Serial ATA International Organization

Serial ATA Revision 2.6 + Gen3i ECN # 027
Title : Gen3i Rx Differential Return Loss Text Description and Figure Change – Clarification Only

Figure 7-10 – Differential Return Loss Limits, ~~Gen3~~Gen3i, **TX and RX**

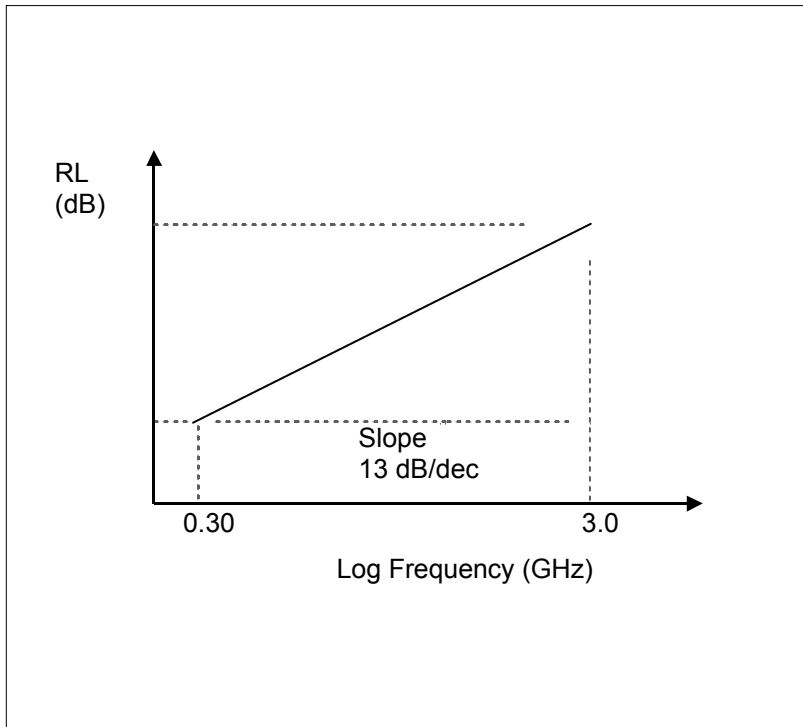
Both the Tx and Rx Differential Mode Return Loss entries in the parametric tables, for Gen3i, make cross references to section 7.2.2.2.6 and then further to Figure 7-10. In our haste to complete the draft, we didn't notice that the Rx references are not in the section headers and Figure 7-10.

Slight variation in the TX and RX parametrics requires a new Figure 7-10 (the drawing below) to show the slight differences in the parametric values.

See the required Figure 7-10 change below, with additional clarification added, to go with the 7.2.2.2.6 text changes shown above.

Current Figure 7-10 as shown in the 0.95 draft:

Proposed Figure 7-10 Change: (a replacement figure, and its **label change**)

(*proposed, first paragraph, last sentence*)
The return loss shall remain below **the line shown in Figure 7-10**, from the starting frequency to the ending frequency.
